**NOTICE OF MEETING**  
**PLANNING AND ZONING COMMISSION**  
**6:30 P.M. – December 12, 2019**

PLANNING & ZONING COMMISSION ITEM:  
VR-19-17  
**VARIANCE**  
CIBOLO CLIFF RANCHES

PLANNING AND ZONING COMMISSION ITEM:  
PC-19-20  
**PRELIMINARY PLAT**  
**CIBOLO CLIFF RANCHES**

**SUBJECT:** 4S Ranch, Unit 7B Prelim Plat Review

CALLED 1279.3662 ACRES  
ELISE ZUERCHER  
(VOL. 494, PG. 754, OPR/CCT)  
FEBRUARY 27, 1988

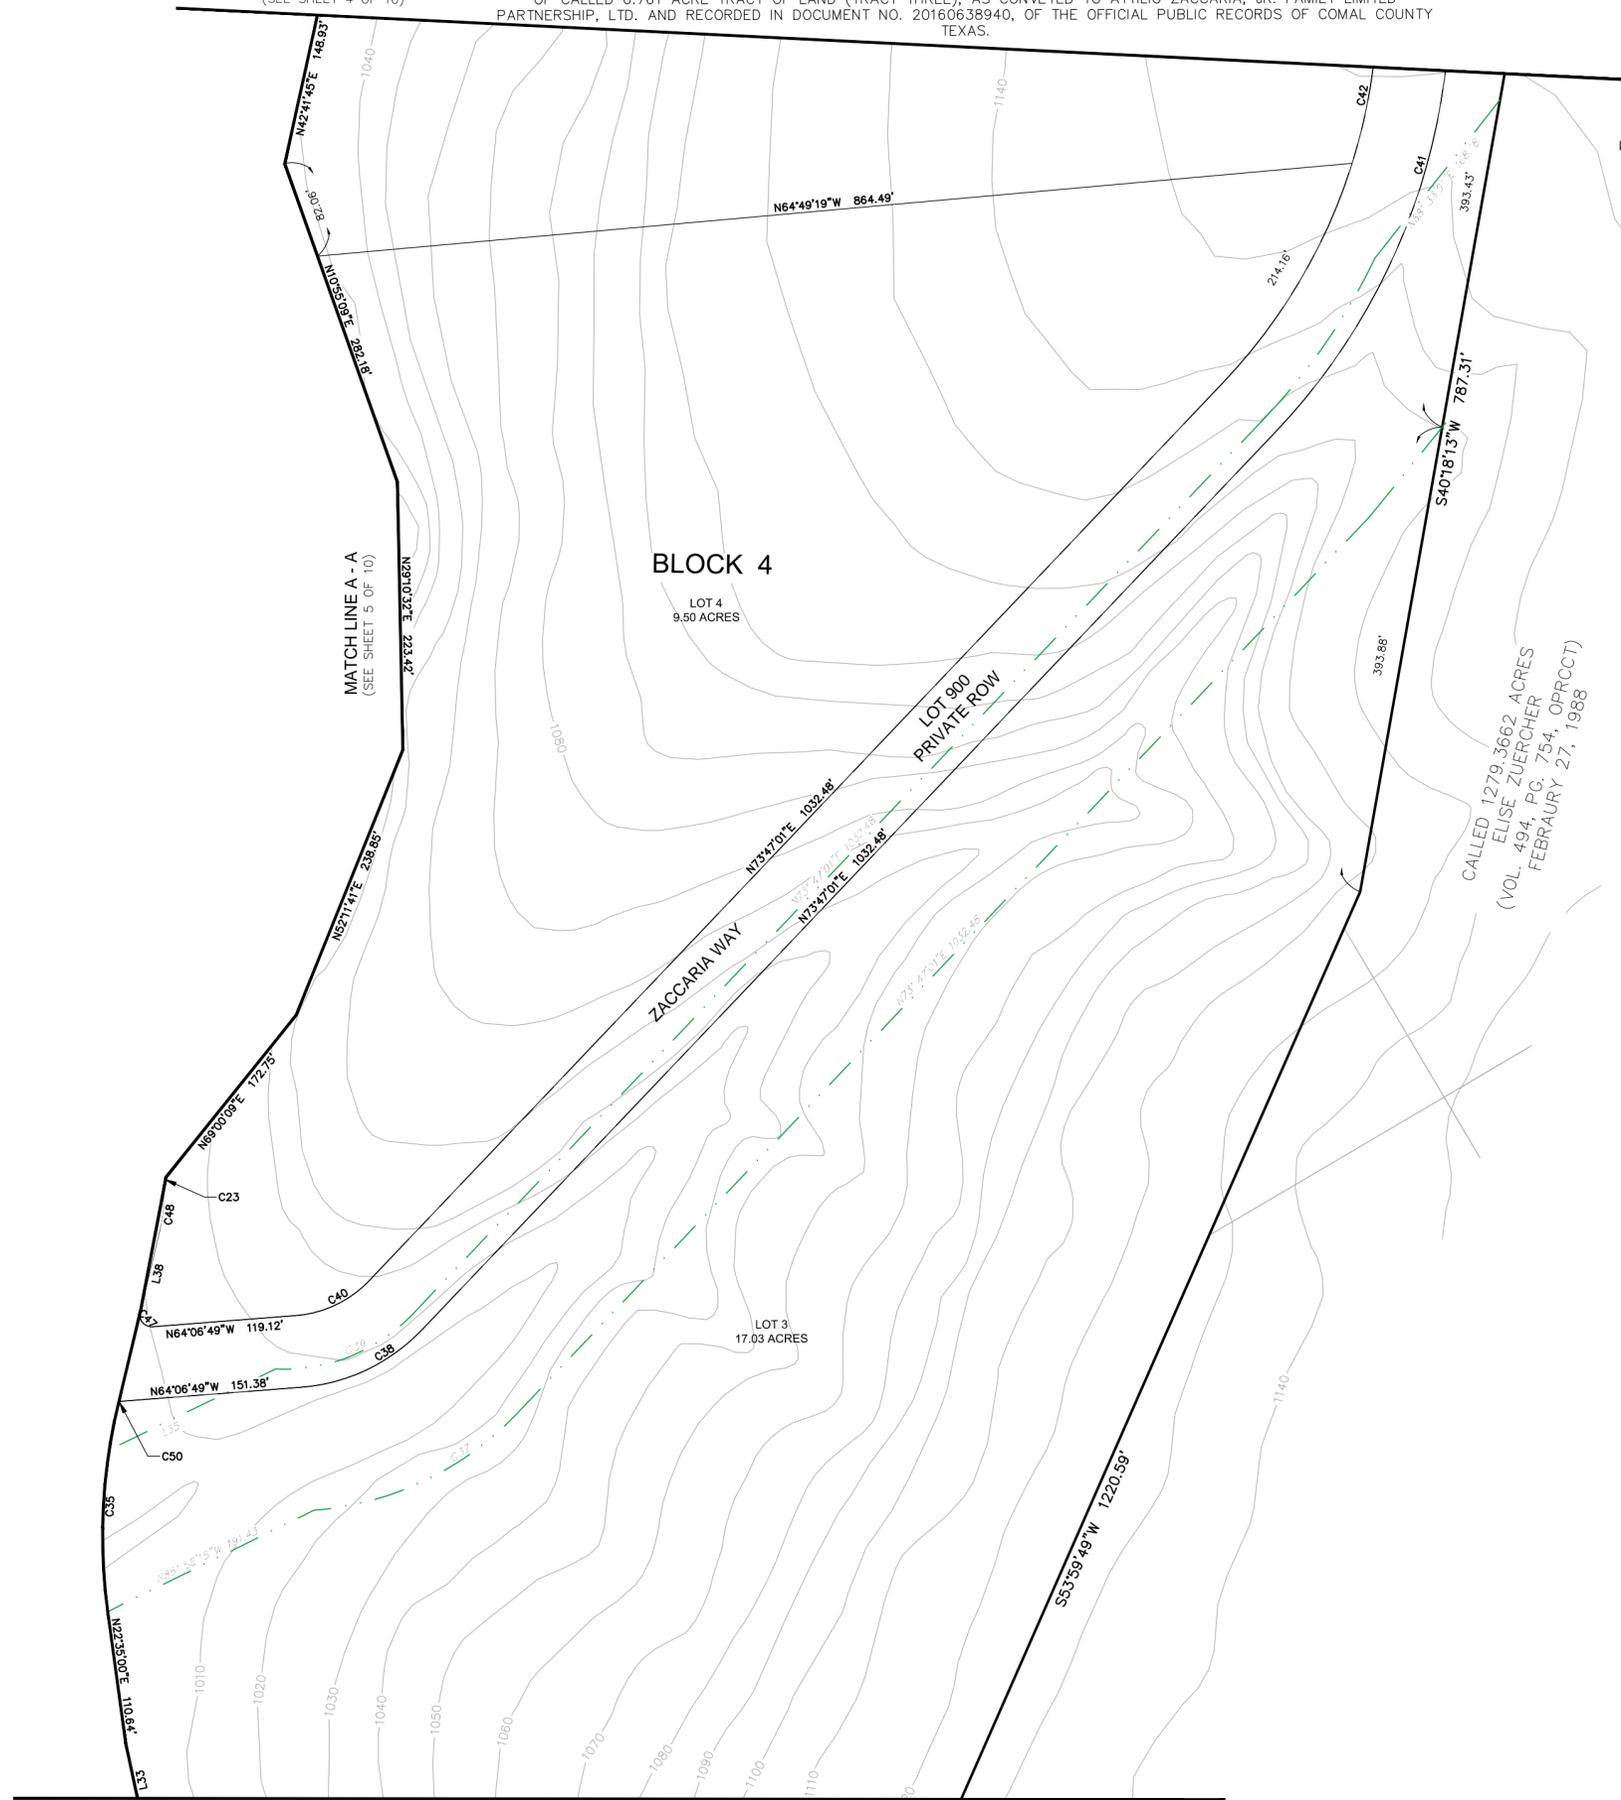
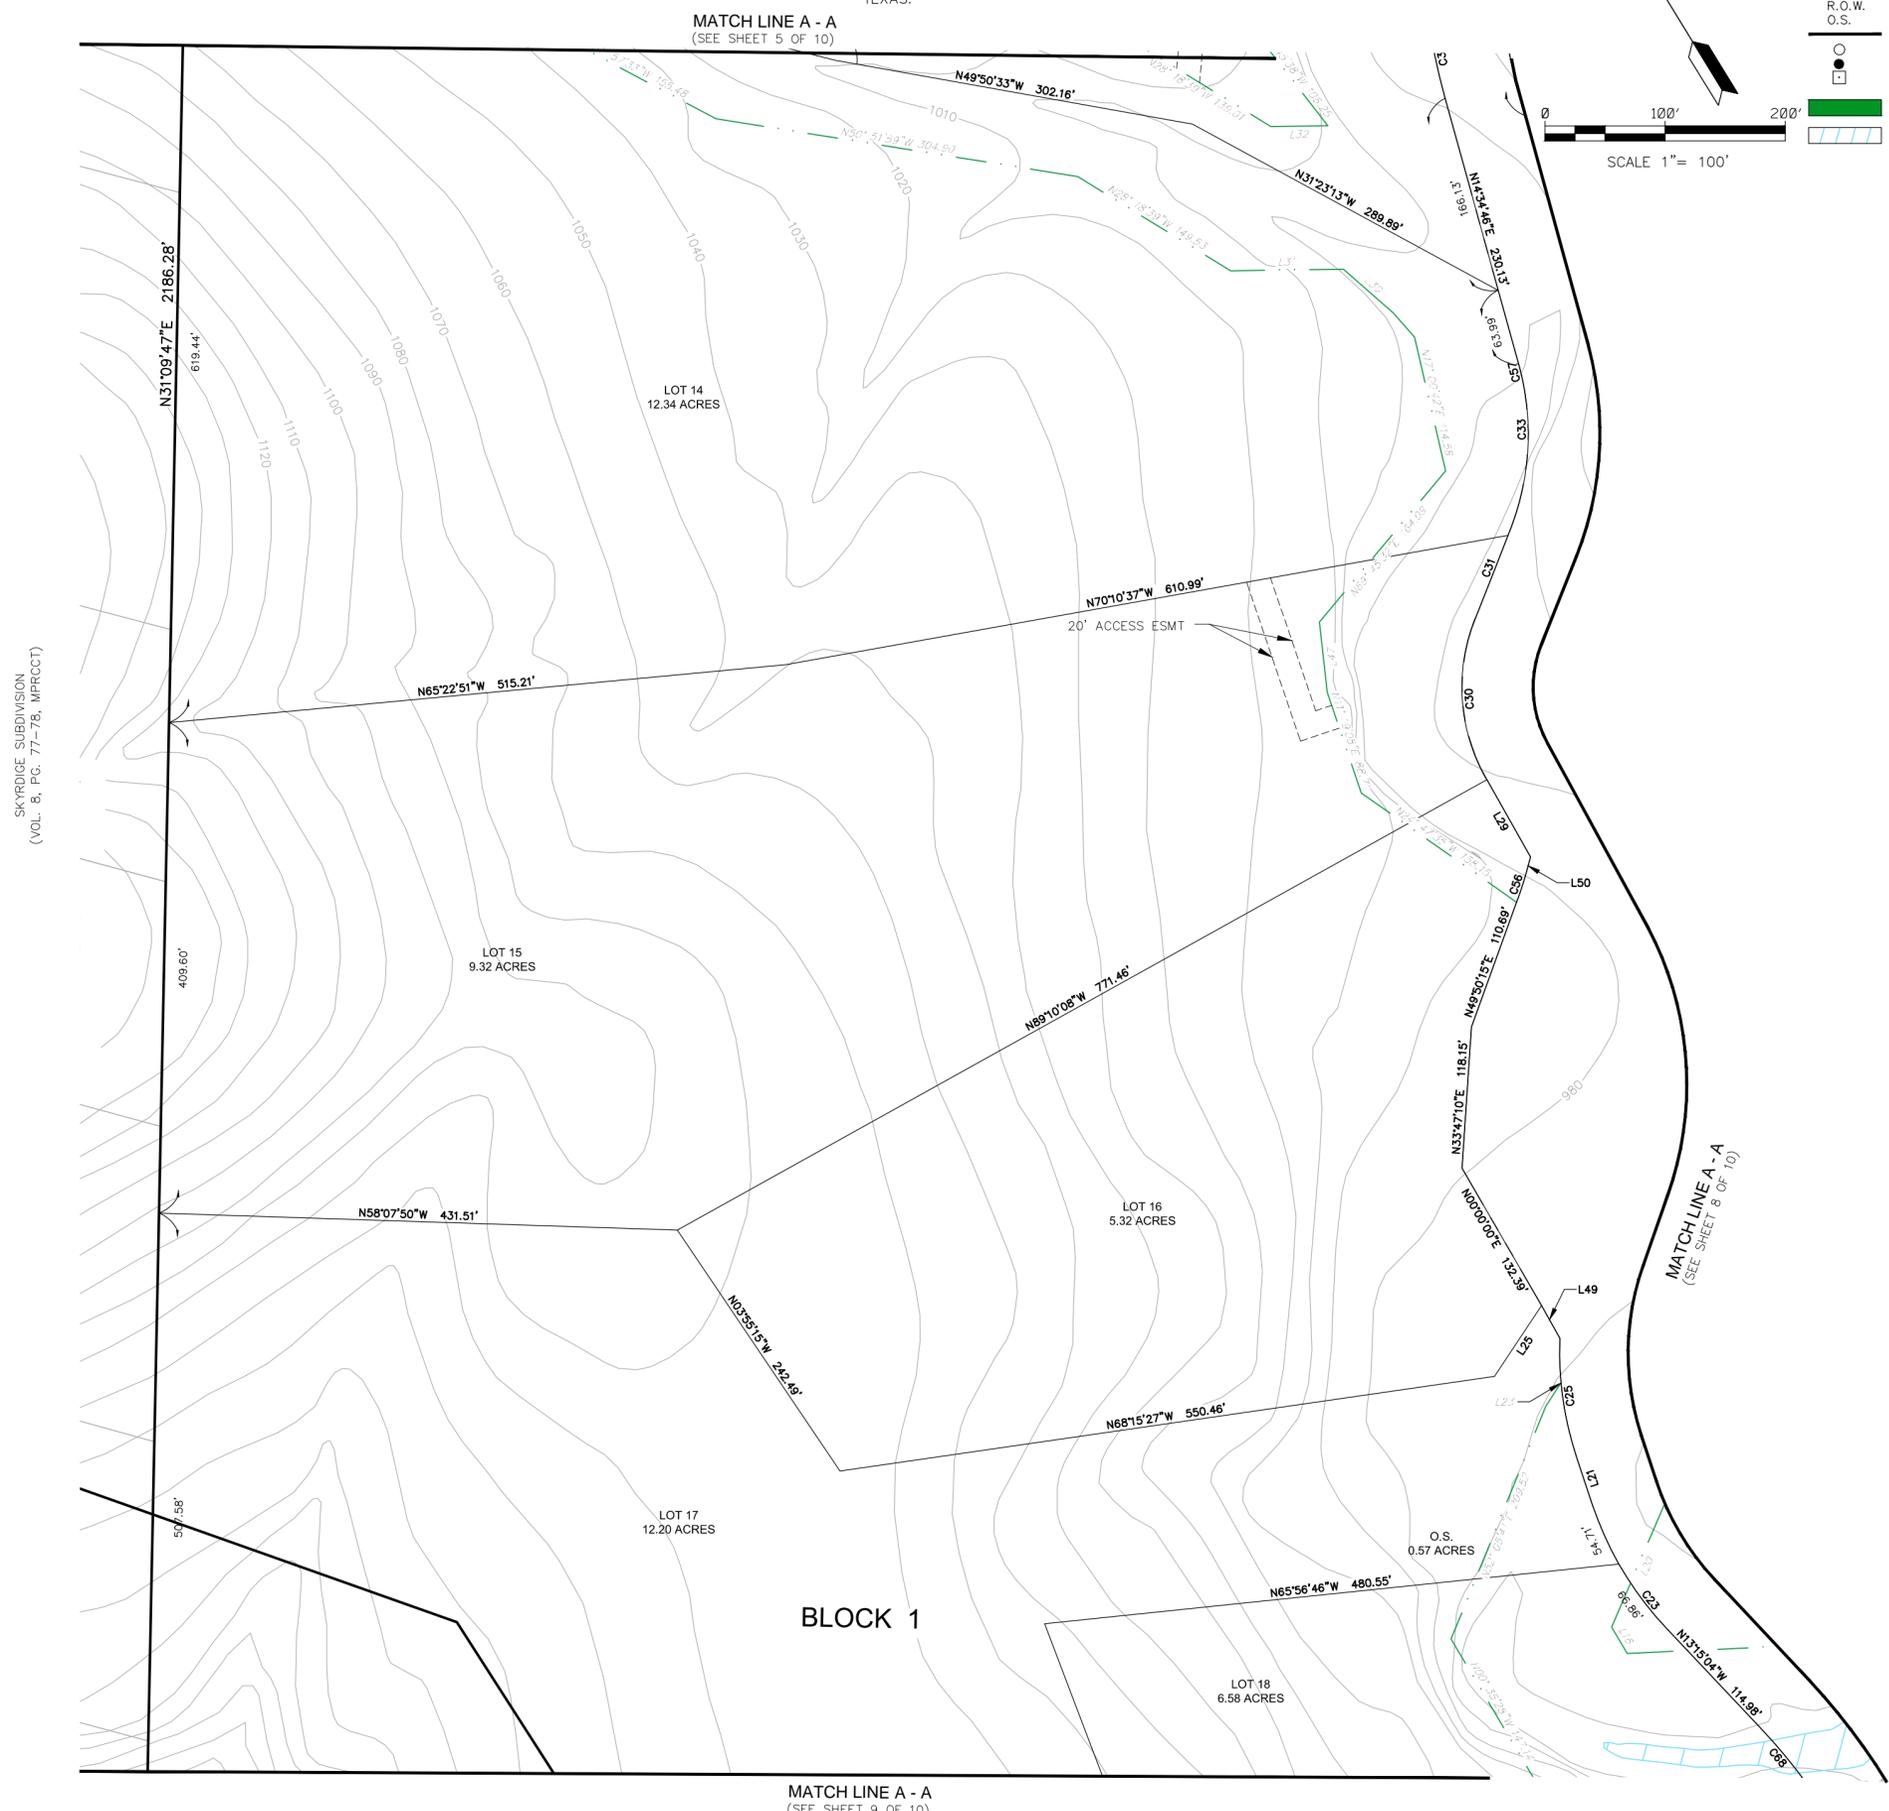
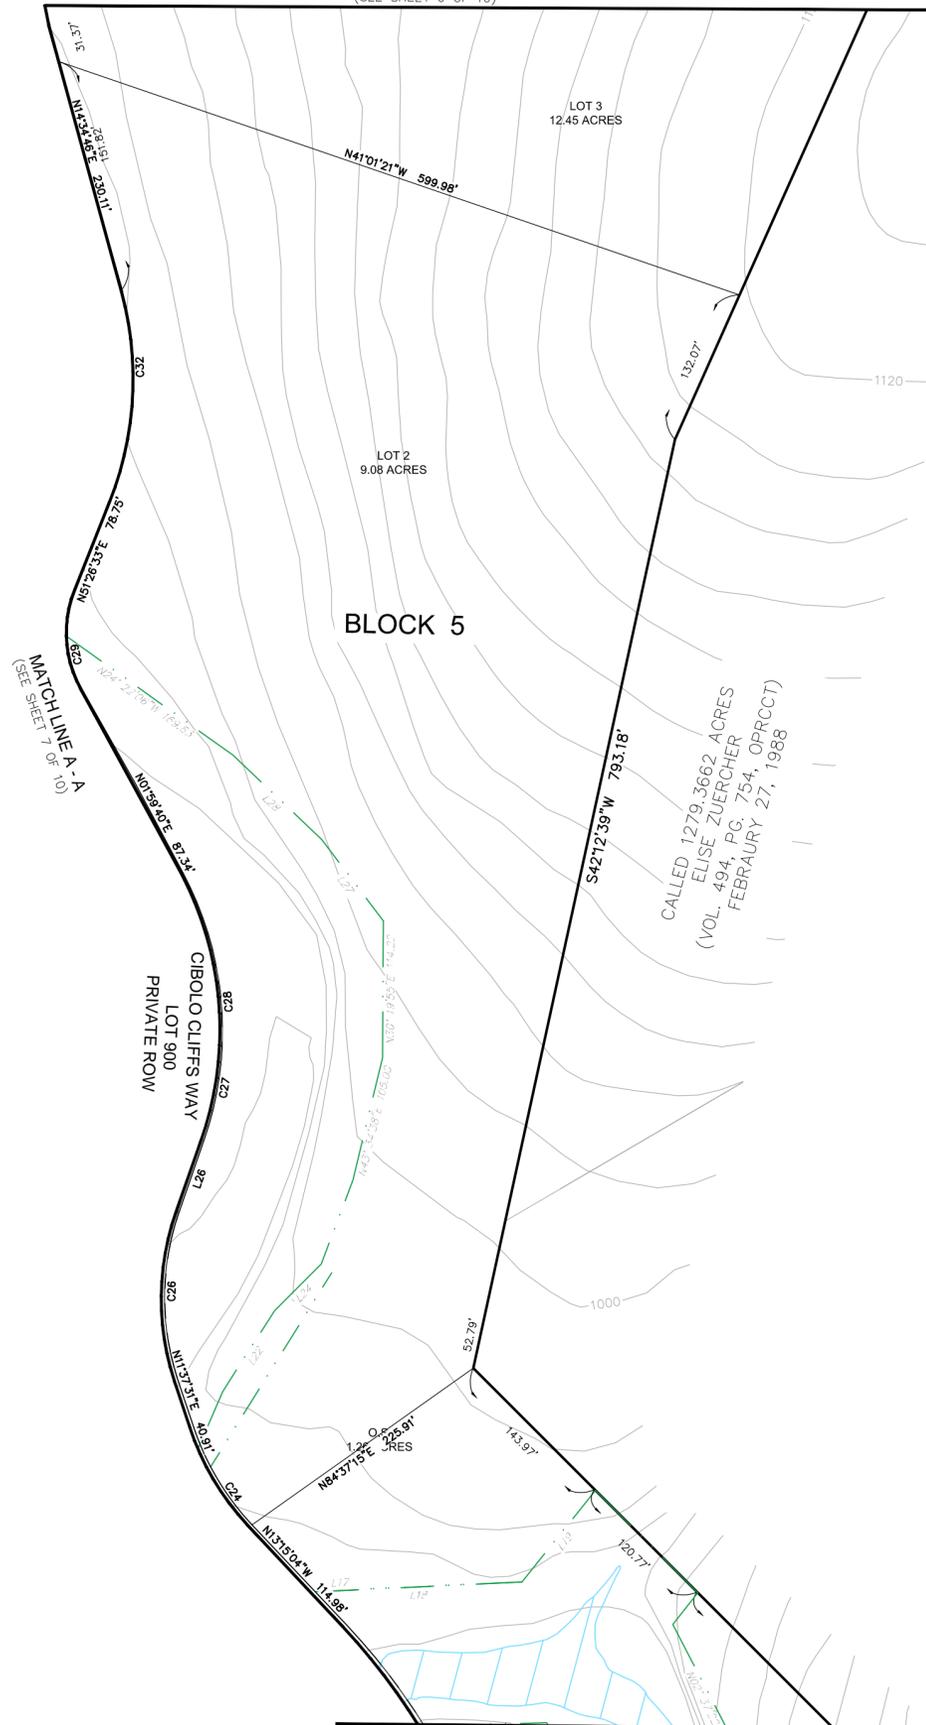
1. Plat scale must not exceed 1" = 100 feet.
2. Missing length of streets
3. Note 13 - revise to say "two feet" instead of one. "...must have a flood slab elevation...a minimum of ~~one foot~~ two feet above the 100-year water flow elevation..."

4. Note 4 & 12 – Lot 900 is open space/drainage easement but includes proposed roadway. Revise to show road ROW separate from drainage easement.
5. Include block numbers for each lot (it's been noted a variance has been requested for block lengths).

8. A minimum of two corners of the subdivision referenced to State Plane Grid Coordinates.
9. Show city limits and limits of the City's ETJ on location map and plat (i.e. FM 1863)

13. Label drawing as "Subdivision Plat", not "Preliminary Plat".
14. Provide acreage of all drainage easements within each lot. Keep in mind, fences will not be allowed within the drainage easements. All easements must be labeled with bearing and direction to a fixed location.

SUBDIVISION PLAT  
 OF  
**MUSTANG VISTA PHASE 4 &  
 AMENITY CENTER #2**

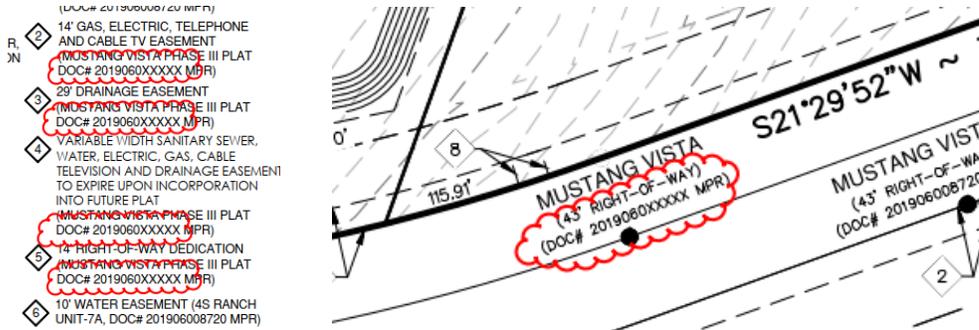
2. No Setback Lines are identified
3. Call out acreage for variable width drainage easement, Lot 1.
4. Sheet 1 of 3, Miscellaneous Note #4 references Mustang Vista Phase III.

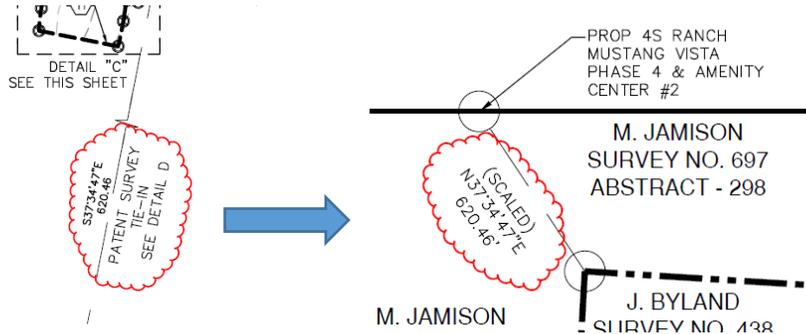
- Sheet 2 of 3, Legend, Several DOC#'s are incomplete. Also incomplete on Mustang Vista ROW call-out.

- Confirm correct bearing from corner of the subdivision to a corner of the original tract or original survey. Sheet 3 of 3 shows SE bearing, Detail "D" shows NE bearing.
